UNITED STATES PATENT AND TRADEMARK OFFICE

10/705,273

Office Action Summary	Application No. 10/705,273	Applicant(s) BROWN ET AL.	
	Examiner Vy Q. Bui	Art Unit 3773

DETAILED ACTION

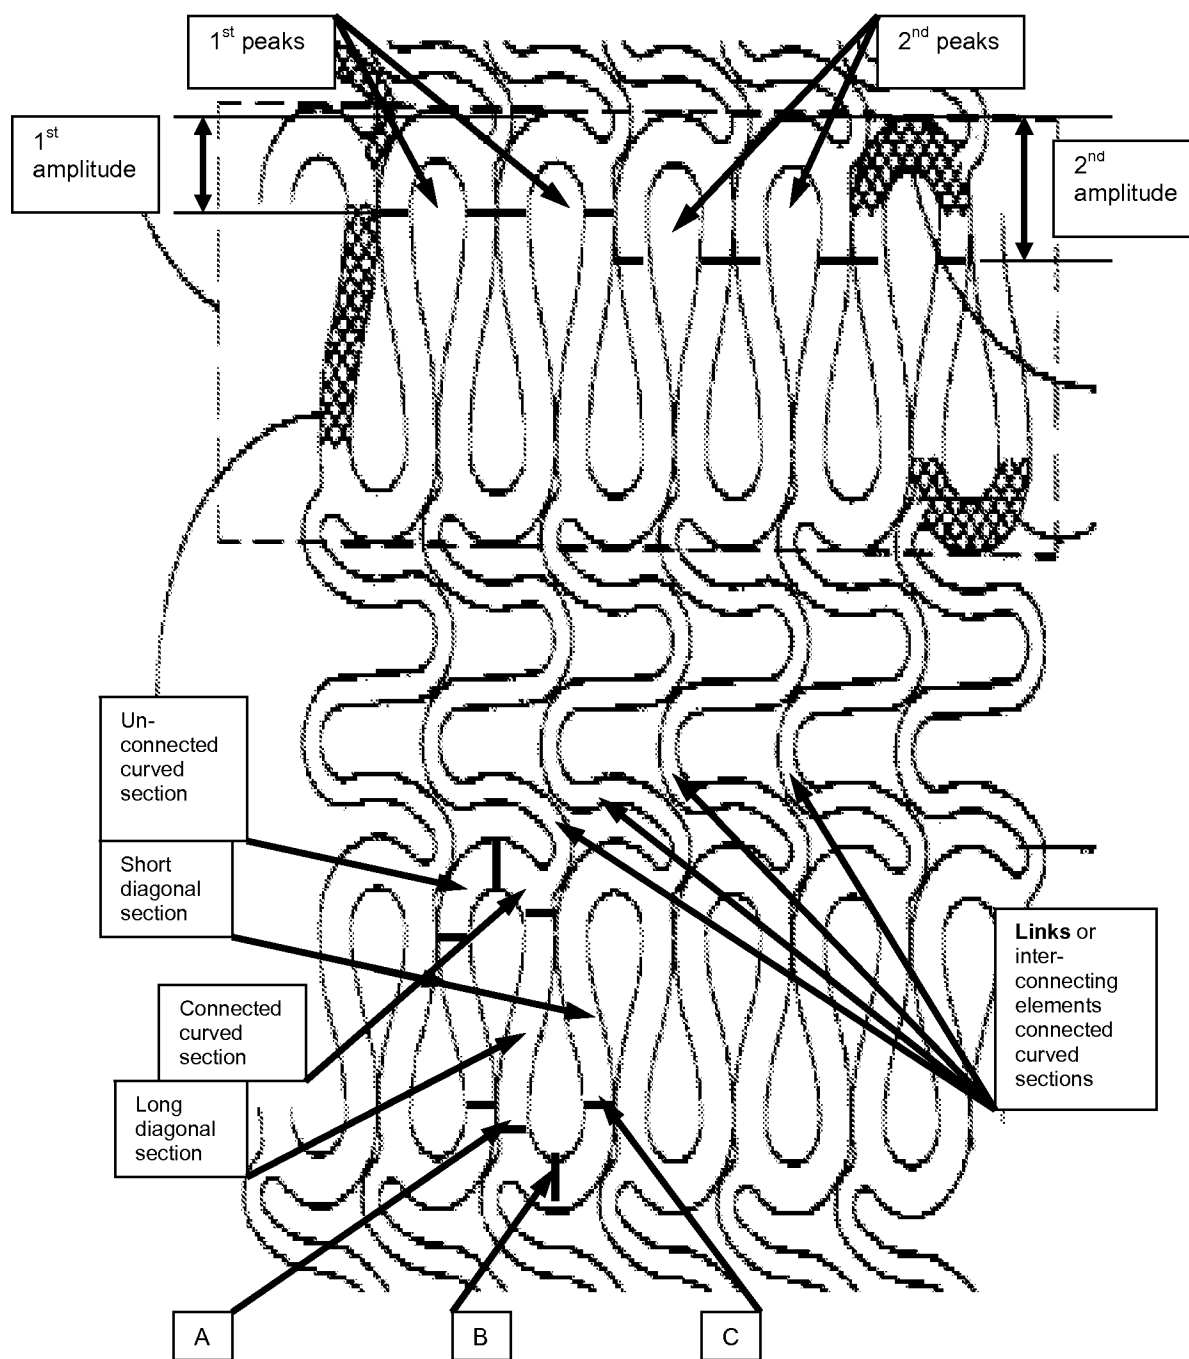
As to claims 38, 42-43, 45, 58-60 and 65, Fischell-'403 discloses a stent made of a stainless steel. Notice that the limitation "short diagonal section", "long diagonal section", "unconnected curved section", "connected curved section", "peaks", and so on in the claims are broadly interpreted. Therefore, partial of Fischell-'403's Fig. 9 reproduced below shows each circumferential set of strut members including links 44 connecting "connected curved sections", short diagonal sections, long diagonal section, unconnected curved sections and connected curved sections to define connected strut members and unconnected strut members substantially as recited in the claims.

Notice that there is nothing in the claims to exclude the interpretation of Fischell-'403's Fig. 9 as presented below.

As to claim 62, the term "peak" is not clearly defined, and one interpretation as indicated in above reproduced F 9 of Fischell-'403 is applicable. It would have been obvious to one of ordinary skill in the art to choose the peaks in Fischell-'403 having 1st amplitude as recited in the claim because this would be reasonable for a person of ordinary skill in the art to look at Fischell-'403 stent.

As to claim 66, as indicated in the above reproduced Fischell-'404's F. 9, 2nd amplitude is greater than 1st amplitude. It would be reasonable for one of ordinary skill in the art to conclude that 2nd peaks extend further toward the 1st end than 1st peaks because 2nd peaks are longer than 1st peaks.

1. limitation "each two adjacent strut members connected by a single curved section" only requires that there is at least one single curved section AB or BC in the connecting member AC (please, see reproduced F 9 of Fischell-'403 above), which has two common points (A and C) to each one of two strut members. Notice that each curved section AB and BC is indeed a single curved section because these section only have a single body (not branched, or not split into two branches, for example).

FIG. 7

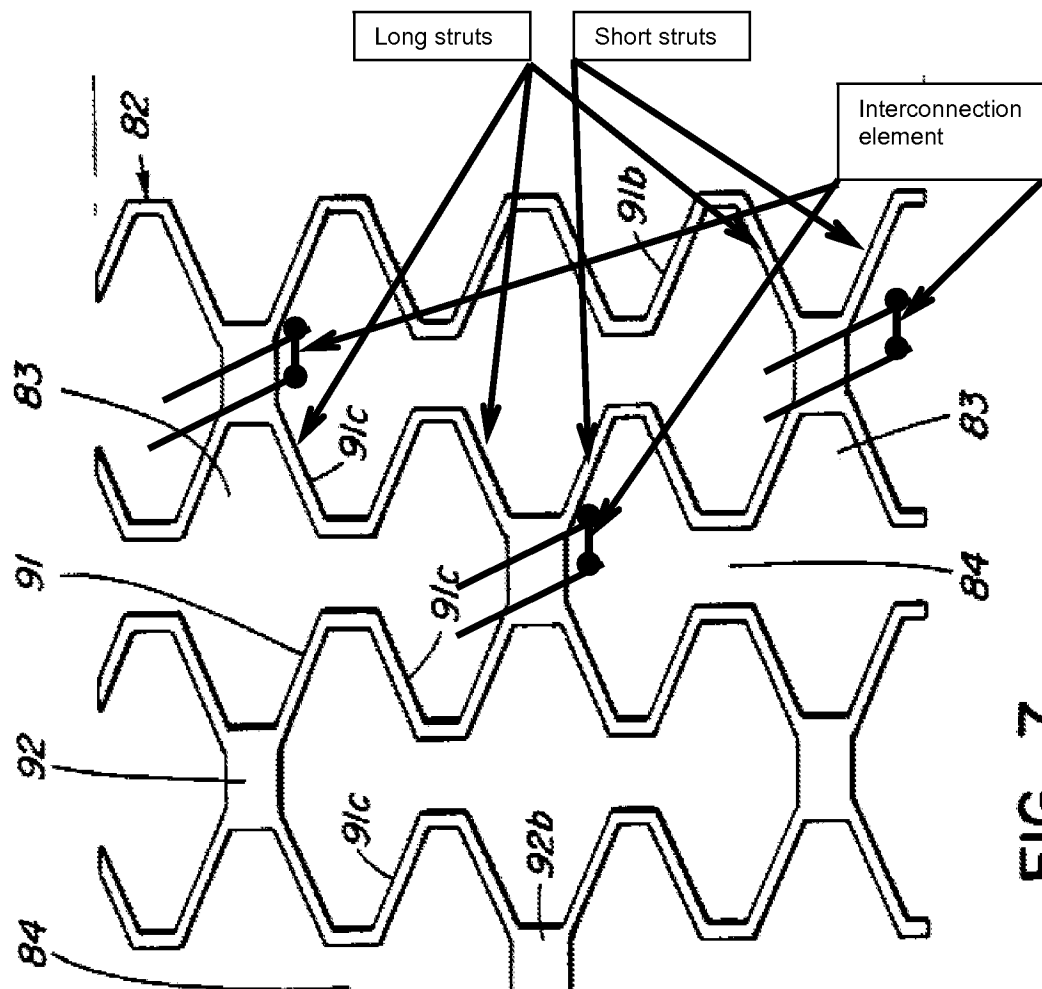
As to claims 67-70, Al-Saadon-'776 (F 7) discloses substantially all the limitations of the claimed invention, such as long struts, short struts, interconnecting elements. Please, notice that the claims do not have any limitation to clearly define a strut (where does it start and end?) or an interconnecting element (where does it start and end?).

Notice that there is nothing in the claims to exclude the interpretation of Al-Saadon-'776 (F 7) as presented below. The applicant is expected to amend the claims to distinguish the present claimed invention over Fischell-'403's.

As such, the claims must be interpreted in a broad and reasonable manner as indicated below:
